U.S. Department
of Transportation
**Federal Highway
Administration**

In Reply Refer To:
HSSI/WZ-141A

This is in response to your July 23, 2009, correspondence requesting the Federal Highway Administration's (FHWA) acceptance of your company's sign stand, model number UF2000T, as a crashworthy traffic control device for use in work zones and elsewhere on the National Highway System (NHS). Accompanying your letter was the FHWA Office of Safety Design form revising the FHWA Acceptance letter WZ-141 (including reference to WZ-17, WZ-25, and WZ-50) to include updated detail drawings of the UF2000T portable sign stand. This modification to the base of the UF2000 involves the addition of a tube receptor in-place of the current u-bracket to be compatible with the sign mast of the QFV-48. This minor modification in design that combines the UF2000 base with the QFV-48 sign mast will be model UF2000T. This modification will not adversely affect the crashworthy performance of this device and it is acceptable for use on the NHS.

Enclosed is information regarding two of our previously accepted portable sign stands UF2000 (WZ-25, 50, 141) and QFV-48 (WZ-17). I am submitting drawings, photos an

UF2000T

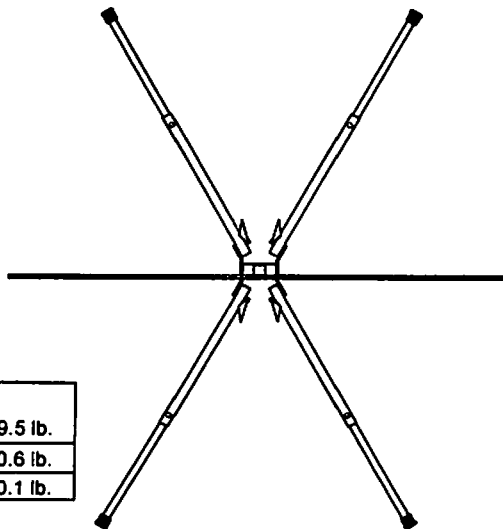
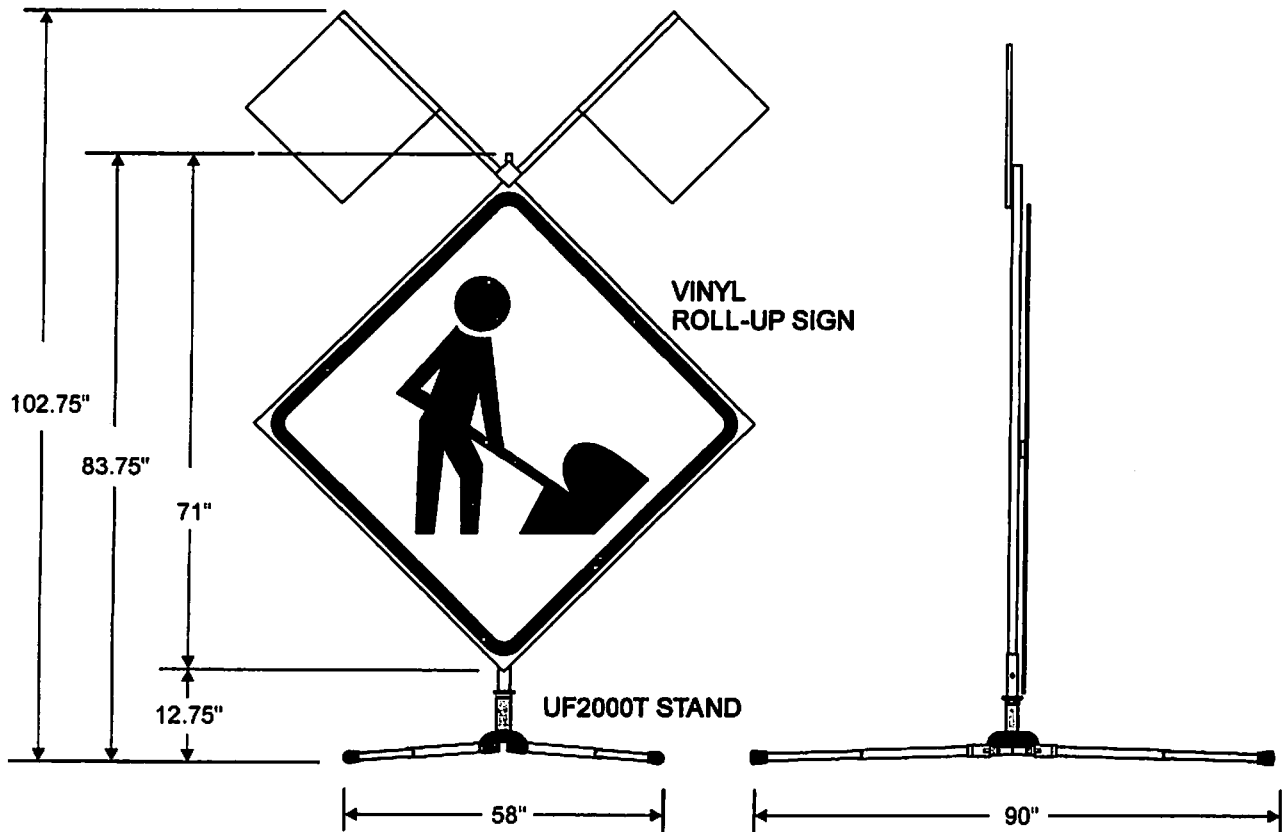
The basic change involves the addition of a tube receptor (similar to that on the QFV-48) onto the UF2000 spring, in place of the current U-bracket. As stated above, when the QFV sign mast is inserted into this tube receptor the bottom of the removable sign mast will be located at the same dimension above ground as the approved stands. In turn, this means that the top of the sign mast will also still be at the same height as the approved stands.

Upon your review of this information we request acceptance of this new stand (UF2000T), based on the fact that the only discernable change is located below bumper height.
